LEES LANE SUBDIVISION, PHASE 1

Engineering Comments: FINAL PLAT COMMENTS (should be addressed prior to submitting the FINAL PLAT for review and/or signature by the City Engineer):

APPLICATION NUMBER 2 DATE October 6, 2022

DETAIL SITE PLAN

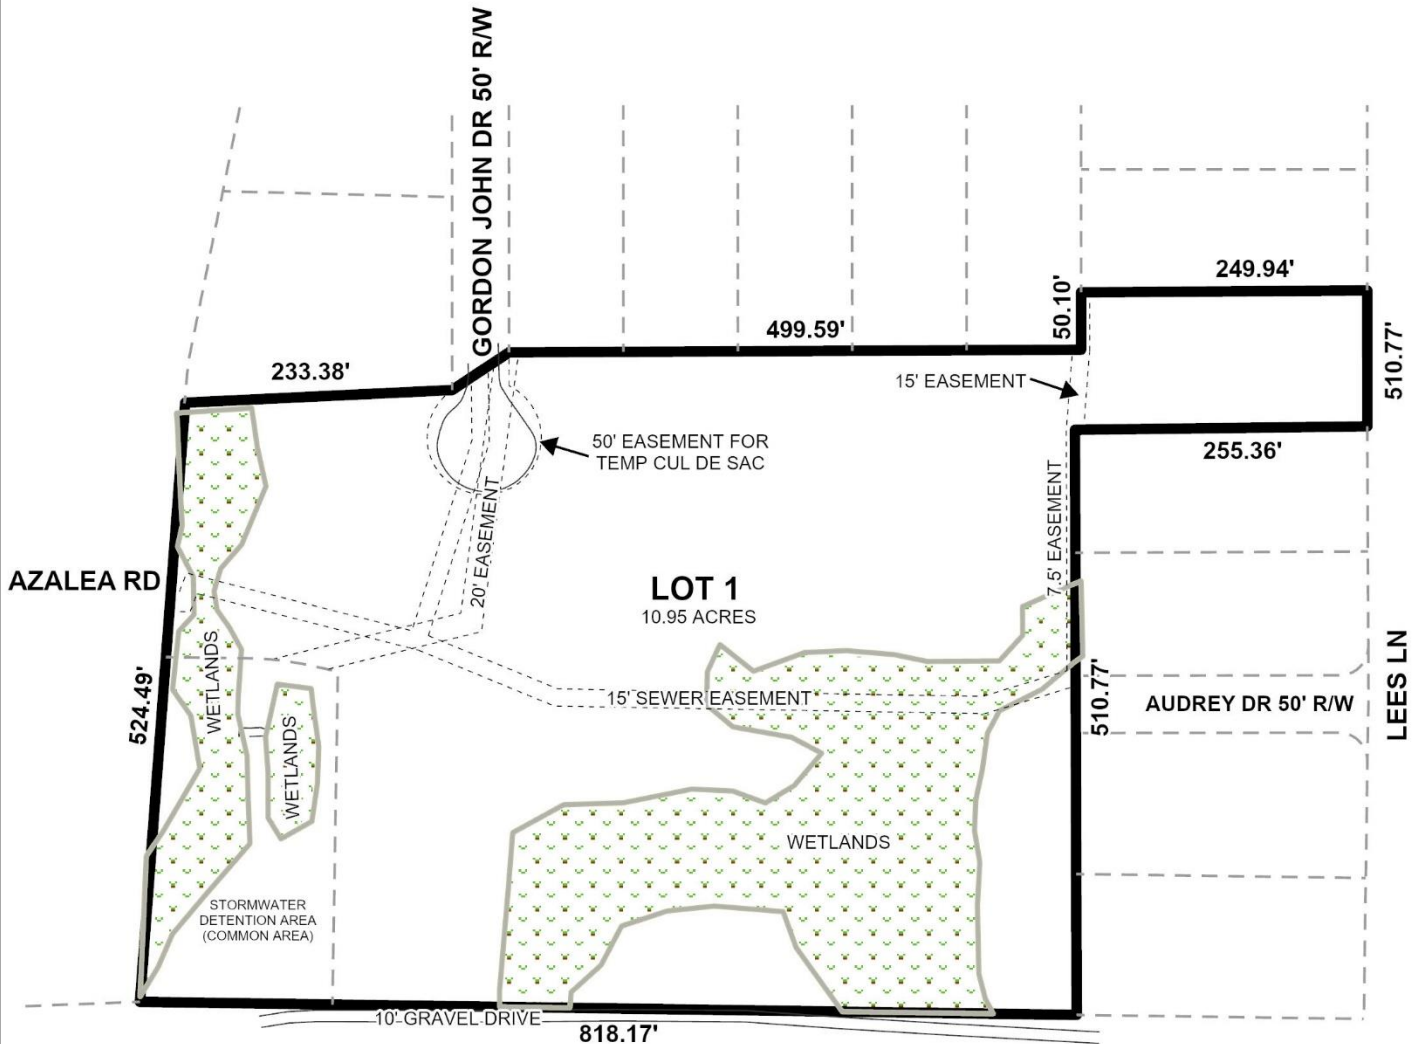
- B. Add legible street names to the vicinity map. Text was too small.
- C. Application form indicates that the Subdivision Name is LEES LANE – Phase 1. Add it to the FINAL PLAT.

- D. Label LEES LANE and show the existing ROW width.
- E. Show and label the existing Azalea Rd. ROW and width.
- F. The Common Area should be a separate lot and not included in the LOT 1 square footage.

- G. Show and label the various lots within recorded subdivisions that are referenced in the written legal description - Lot 2, Meador Subdivision, First Addition; Lot 1 Contel Cellular Sub. No. 3; S&L Industrial Park Phase One; Lot 1 Wanda Place.

- H. Revise PLAT NOTE #5 from “ALL PROPOSED...” to “ALL EXISTING AND PROPOSED...”.
- I. Review and revise the written legal description to change “COMER” to “CORNER”.

- J. Review and revise the written description or the written bearing and distance for the portion at the south end of Gordon John Dr.
- K. After the revisions for the Common Area and the Public ROW are made you will need to revise the LOT 1 square footage.

- L. Dedicate Public ROW to the City of Mobile for a 120’ diameter cul-de-sac at the south terminus of Gordon John Dr. to replace the existing 50’ temporary cul-de-sac easement, and list the amount of dedicated acreage (SF and AC).

- M. Check and clarify PLAT NOTE #11. The drawing indicates WETLANDS PER BARRY VITTOR ASSOCIATES and the NOTE indicates that the information is from NWI data and has not been delineated.

- N. Provide a note that a 25' riparian buffer may be required, during development, along the edge of anything considered by ADEM to be a water of the state.

- O. Show and label all flood zones and floodways.
- P. Show and label the MFFE (Minimum Finished Floor Elevation) on each lot that contains an AE, V, or X (shaded) flood zone designation. The BFE is 11’.

- Q. Show and label each and every Right-Of-Way and easement.
- R. Add a note to the SUBDIVISION PLAT stating that as shown on the 1984 aerial photo LOT 1 will receive historical credit of existing (1984) impervious area towards stormwater detention requirement per Mobile City Code, Chapter 17, Storm Water Management and Flood Control) as follows: LOT 1 – NONE.

- S. Add a note that sidewalk is required to be constructed, and/or repaired, along the frontage of each lot, or parcel, at time of new development or construction, unless a sidewalk waiver is approved.

The proposed site has frontage on Gordon John Drive, a minor street with curb-and-gutter requiring a 50-foot right-of-way; Audrey Drive, an unopened right-of-way with a compliant 50-foot right-of-way; Azalea Road, a minor street with curb-and-gutter requiring a 50-foot right-of-way; and Lee's Lane, a minor street without curb-and-gutter, requiring a 60-foot right-of-way. The preliminary plat illustrates a compliant 50-foot right-of-way for both Audrey Drive and Gordon John Drive, thus no additional dedication is required. As on the preliminary plat, the right-of-way widths of Gordon John Drive, Audrey Drive, and Azalea Road should be retained on the Final Plat, if approved. If approved, the Final Plat should include the width of Azalea Road and Lee's Lane providing dedication, if necessary.

It should be noted that the preliminary plat depicts a 50-foot easement for a temporary cul-de-sac at the terminus of Gordon John Drive. As required by Engineering, the plat should be revised to illustrate dedication of a 120-foot diameter cul-de-sac to replace the existing 50-foot temporary cul-de-sac easement. If approved, the amount of dedicated area as a result of the dedication should also be depicted on the Final Plat, provided in both square feet and acres.

The preliminary plat submitted does not illustrate a proposed 25-foot minimum building setback line along the street frontages, which is required by Section V.D.9 of the Subdivision Regulations. If approved, the Final Plat should illustrate a 25-foot minimum building setback along all street frontages, adjusted for any dedication.

The preliminary plat illustrates multiple easements on the property. If approved, a note should be placed on the Final Plat stating no structures shall be constructed in any easement without permission of the easement holder.

The proposed lot is approximately 476,982± square feet which exceed the minimum size requirements of the Subdivision Regulations. However, the size of the lot is not illustrated in square feet and acres. If approved, the Final Plat should be revised to label the lot's size in both square feet and acres, adjusted for any dedication, or a table on the Final Plat with the same information may suffice.

As illustrated the submitted plat meets the minimum requirements of the Subdivision Regulations and is recommended for Tentative Approval subject to the following conditions:

- 1) Retention of the right-of-way widths of Gordon John Drive and Audrey Drive;
- 2) Revision of the Final Plat to depict the existing right-of-way for Azalea Road, and provide dedication, if necessary, to provide 25-feet to the centerline

- 3) Revision of the Final Plat to depict the existing right-of-way for Lee's Lane, and provide dedication, if necessary, to provide 30-feet to the centerline;

- 4) Retention of the 50-foot easement for a temporary cul-de-sac at the terminus of Gordon John Drive;
- 5) Revision of the Final Plat to depict the 25-foot minimum setback line along all street frontages, adjusted for any dedication;

- 6) Placement of a note on the Final Plat stating no structures shall be constructed in any easement without permission of the easement holder;
- 7) Revision of the Final Plat to provide the size of the lot in both square feet and acres, or provision of a table on the Final Plat with the same information;
